Senninger Farms LLC  
11107 Cedar Creek Road  
Louisville, KY 40229

We are writing to you today to express our concerns about the proposed application and development plan for the Cedar Creek Subdivision at 10803 Cedar Creek Road in Louisville. We are members of the family long residing at the adjacent property, 11107 Cedar Creek Road; the property has always been a home away from home for us and all of our growing family of over 70 people, for almost a century. As we have spent much of our lives as children and adults there, we all truly value the land, its surroundings, and especially its future.

I am writing to you regarding case # 18SUBDIV1013, and respectfully ask that you share my comments with the Planning Commission. It was with great disappointment that we learned of the proposed subdivision of this property, 10803 and 10809 Cedar Creek Road, adjacent to our family homestead.

**Figure C. Site Analysis Plan development with explicit superimposed tree mass definitions.**

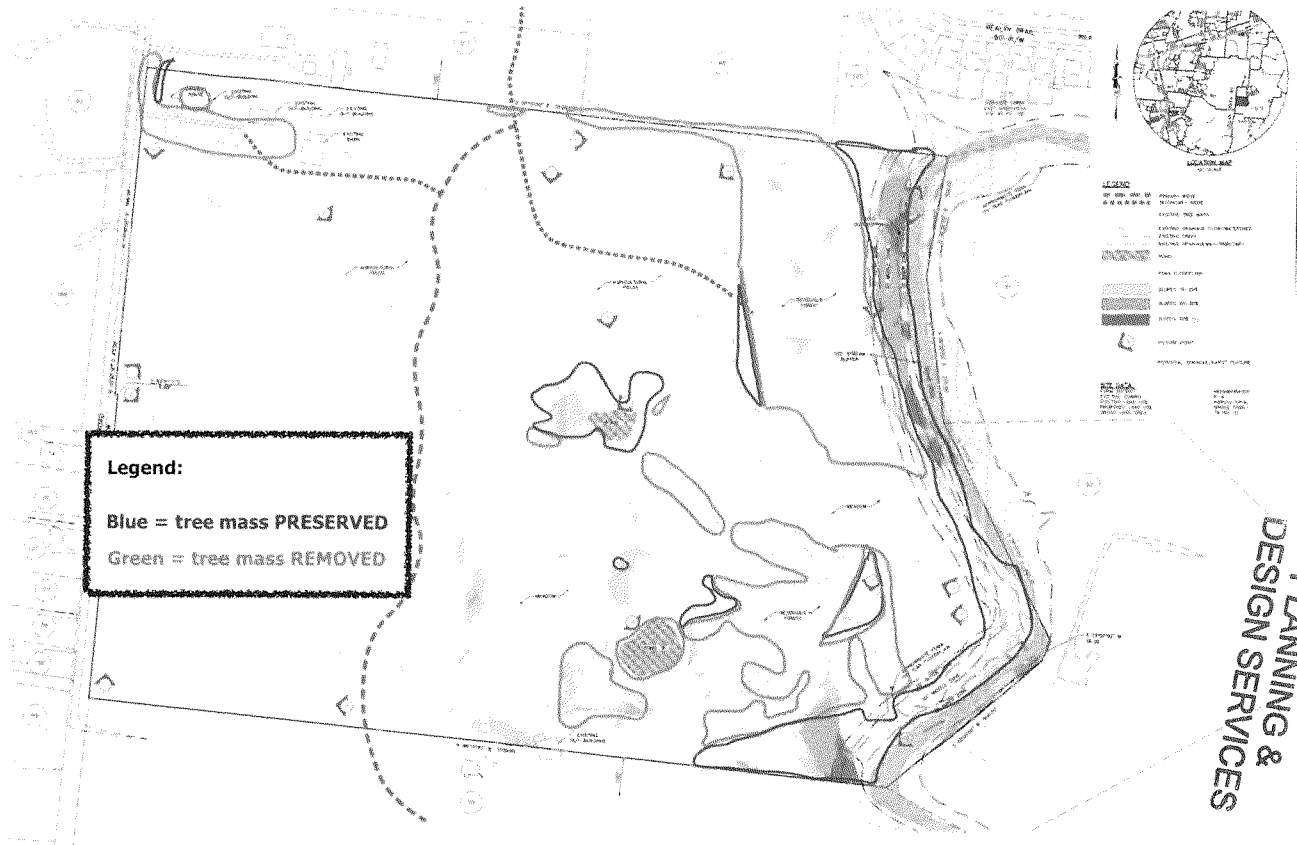
The modified Site Analysis Plan overlay shown in Figure C, clearly carves out a majority of the mature tree mass, especially on the eastern half of the property towards the creek.

**At face value, the Site Analysis Plan does not preserve the mature living forest and therefore does not submit to the rules of a Conservation Subdivision and “preserve in perpetuity: Unique or sensitive natural resources such as groundwater... streams, woodlands, and wildlife corridors and habitat (7.11.3.G.1).”**

Figure D. Rough approximation of natural spring location.

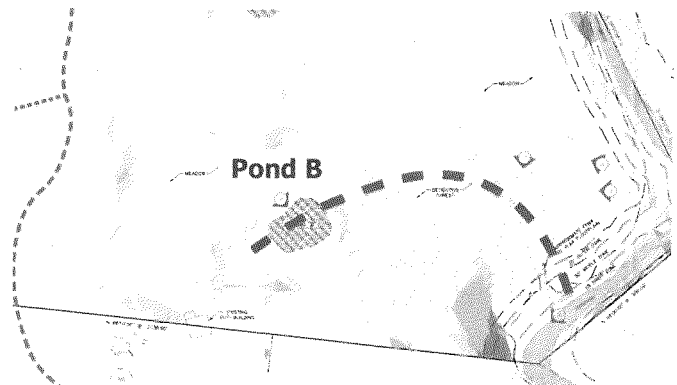
In addition, the proposed Site Analysis Plan will also cut through a natural spring (shown in Figure D denoted by the dotted red line) that leads into and through Pond B, of which the Letter of Explanation also conveniently fails to mention the destruction of. This also directly contradicts section 7.11.3.G.1 as previously stated, to *“preserve in perpetuity: unique or sensitive natural resources such as... streams.”*

1. Preservation of the natural spring shown in Figure D.
2. Preservation of the majority of the mature tree mass and an explanation as to how the proposal is "[*maximizing the*] number of trees preserved (*Letter of Explanation*)," to "[*preserve*] and [*retain*] natural cover (7.11.7.C.4)."

**Figure G. Overview of Parkside at Mt. Washington and Cedar Creek Subdivision proximity.**

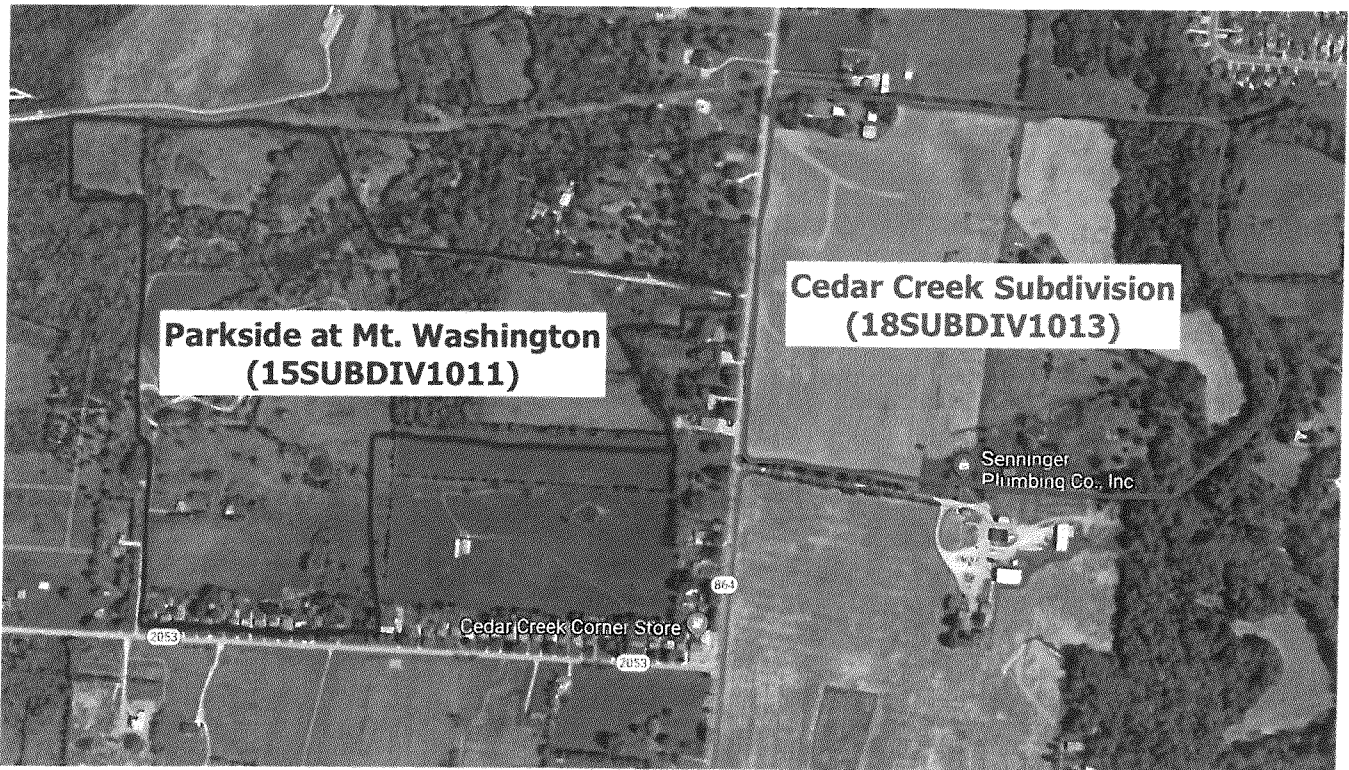
Through the years, there have been multiple subdivision developments in the area surrounding this property. Primrose Meadows for example, which sits right across Cedar Creek (the actual creek), contains *empty* lots and homes listed on the market. Heritage Creek Subdivision, created for the airport relocation program in the late 90s, less than a mile up Cedar Creek, has also failed to fill all of its lots and homes. From the onset, when Minor Lane Heights homeowners were offered houses in Heritage Creek at no cost, the subdivision maintained vacancies. In the last few years these houses were offered to the public, and still there are vacancies. In addition, the Parkside at Mt. Washington Subdivision (2015), which will incorporate 254 homes into a 74.7 acre plot sits less than a mile down the road and essentially right across the street from this proposed subdivision as shown in Figure G.

If subdivisions like Primrose Meadows and Heritage Creek persistently contain open lots and vacant houses, and a subdivision directly across the street will be introducing 254 homes, where is the demand for a new 266 lot subdivision within a 2 mile radius of the existing subdivisions?
